Project	IEEE 802.16 Broadband Wireless Access Working Group < http://ieee802.org/16 >	
Title	Relay Support for Scheduling, Bandwidth Request and Allocation Mechanism	
Date Submitted	2006-11-07	
Source(s)	Haihong Zheng, Yousuf Saifullah, Shashikant Maheshwari Nokia 6000 Connection Drive, Irving, TX	Voice: 972 894 5000 Fax: Haihong.1.zheng@nokia.com Yousuf.saifullah@nokia.com , shashikant.maheshwari@nokia.com
Re:	This is in response to the call for proposals 80216j-06_027.pdf .	
Abstract	This contribution proposes scheduling, bandwidth allocation and request mechanism for multi-hop relay system	
Purpose	Add proposed spec changes in P802.16j Baseline Document (IEEE 802.16j-06/026)	
Notice	This document has been prepared to assist IEEE 802.16. It is offered as a basis for discussion and is not binding on the contributing individual(s) or organization(s). The material in this document is subject to change in form and content after further study. The contributor(s) reserve(s) the right to add, amend or withdraw material contained herein.

Relay Support for Scheduling, Bandwidth Request and Allocation Mechanism

Haihong Zheng, Yousuf Saifullah, and Shashikant Maheshwari
Nokia

Figure 44a: UL allocation synchronization across relays

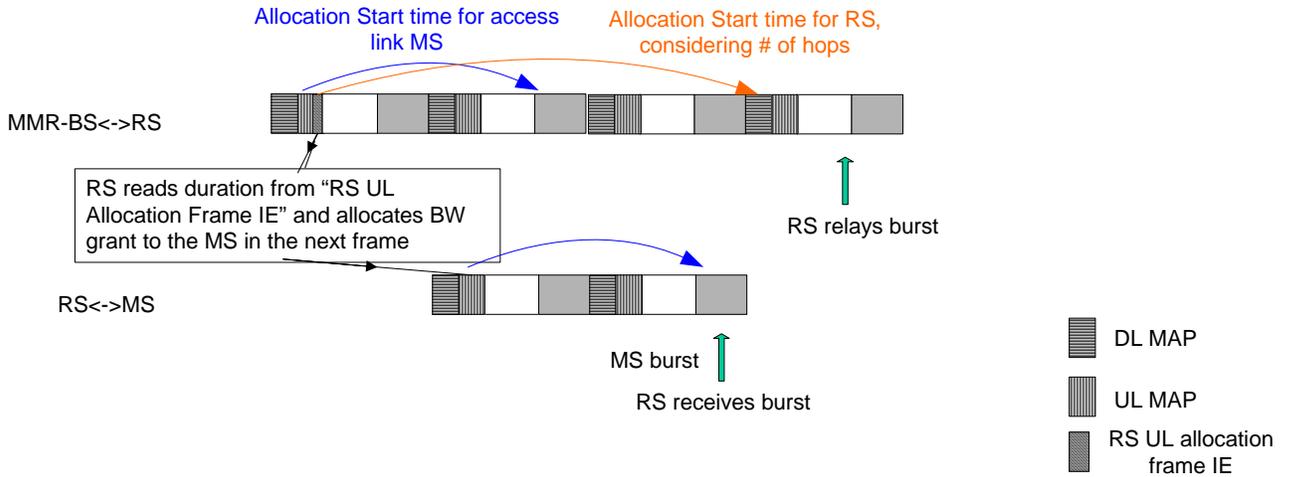
6.3.6.7.2.2 Bandwidth Grant

Due to the nature of distributed scheduling, an uplink burst experiences delay in number of frames at each hop. Therefore, bandwidth grant by MMR-BS/RS needs to be synchronized over multiple hops, such that the bandwidth grant is available when the uplink burst is relayed to the MMR-BS. This synchronization is achieved by indicating the bandwidth grant over multiple frames as indicated in Figure 44a.

The MMR-BS indicates the frame (containing the bandwidth grant) to the direct downlink RS by using the RS UL allocation frame IE. The RS reads the UL MAP at the RS UL allocation frame IE, and relays the burst in the granted bandwidth. If there are more than one RS in the path to the MS/SS, then each RS issues RS UL allocation frame IE appropriately to its downlink RS. The RS UL allocation frame IE is not needed for the access link, and the allocation start time field in the UL-MAP is used to indicate the UL sub-frame.
